Exhaust joint improvement, model My18-My19

MANDATORY

1P04-0022 00 - Replacement bronze bush exhaust VITTORAZI

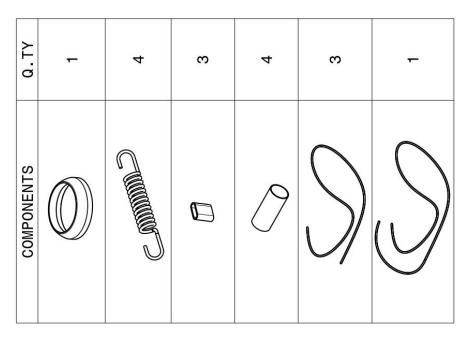
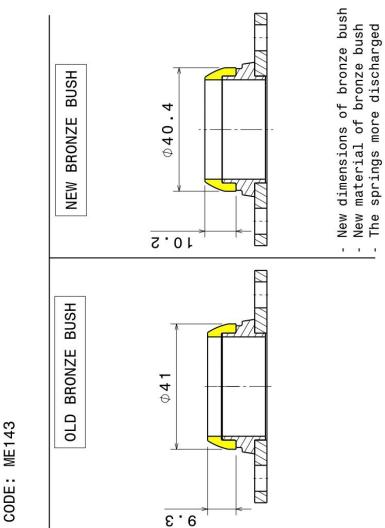
- with the new bush kit even in hard use conditions, the blockage due to steps have been removed. Periodic replacement of the brass ring remains the same: within 30 hours. Below a picture of the new bush that worked correctly for 30 hours.

- In the next picture the previous series bushing, which worked for 30 hours in the same procedure test. The damage to the material and the steps that prevent the correct functioning of the joint system are clearly visible.

- 1. the different profile that avoids the seizure of the joint;
- 2. the change of the bronze alloy which improves the sliding and duration;
- 3. the lower load of the springs which decreases the mechanical stress on the parts involved.
